Access Compliance Report

Public Rights-of-Way

(Curb Ramps)

Intersection ID: 48955	Main Street: ROYA_PL	Cross Street: DAVID_JENNINGS_AV	Location: W
ADA ID: 7F1F59BAAD05	Ramp Type: Perp	Initial Pass/Fail: Pass	Overall Compliance: No
Severity Score: 5			
Codes/Mitigation Info/Possible Solution		Field Measurements/Component Compliance

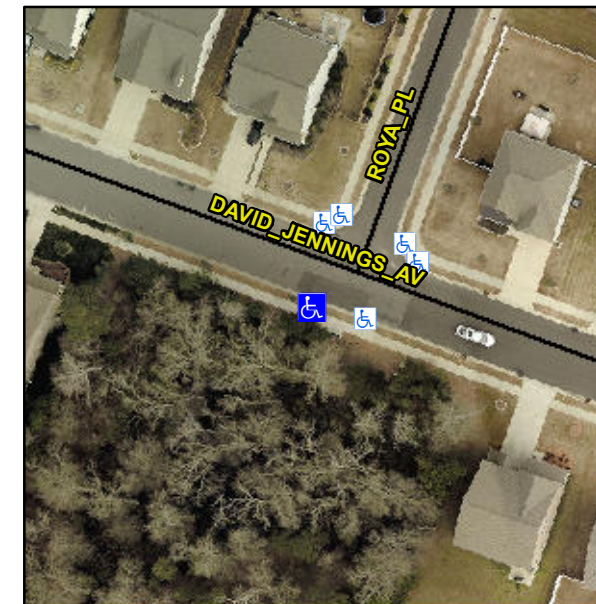
**Not Found, R305.2, R304.5.4,
R304.5.3**

Compliance	Description	Data	Compliance	Description	Data
N/A	Ramp Length (in)	46.5	Yes	Ramp Slope (%)	7.6
Yes	Ramp Width (in)	48.0	Yes	Ramp XSlope (%)	1.2
N/A	Flare Type LT	Sloped	N/A	Flare Type RT	N/A
N/A	Flare Slope LT (%)	2.3	N/A	Flare Slope RT (%)	7.2
N/A	Flare Traversable LT?	No	N/A	Flare Traversable RT?	No
Yes	Landing Length (in)	60.0	Yes	DWS Provided?	Yes
Yes	Landing Width (in)	48.0	Yes	DWS Contrast?	Yes
Yes	Landing Slope (%)	1.3	Yes	DWS Length (in)	24.0
Yes	Landing X Slope (%)	1.2	Yes	DWS Full Width?	Yes
N/A	Landing Curb? (Y/N)	No	No	DWS Offset (in)	3.0
N/A	Shared Landing?	No			
Yes	Gutter Ponding?	No	No	Gutter Slope (%)	7.6
Yes	Gutter Lip Ht (in)	0.0	No	Gutter X Slope (%)	3.6
N/A	Painted X Walk1?	No	N/A	Painted X Walk2?	N/A
	X Walk 1 Direction	To N		X Walk 2 Direction	N/A
N/A	X Walk 1 Width (in)	N/A	N/A	X Walk 2 Width (in)	N/A
	X Walk 1 Slope (%)	5.8		X Walk 2 Slope (%)	N/A
	X Walk 1 X Slope (%)	0.5		X Walk 2 X Slope (%)	N/A

N/A	Ramp inside XWalk1?	N/A	N/A	Ramp inside XWalk2?	N/A
	Road Slope (%)	N/A	N/A	Clear Space?	Yes
	Road X Slope (%)	N/A	N/A	Clear Space to XWalk (in)	N/A
Yes	Any Obstructions?	No	Yes	Storm Grate/Utility Hazard?	No
	Obstruction Type			Storm Grate/Utility Type	
		N/A			N/A
			Yes	Surface Condition? (G/P)	Good

**Remove & Replace Entire Ramp.
Remove & Replace Gutter.**
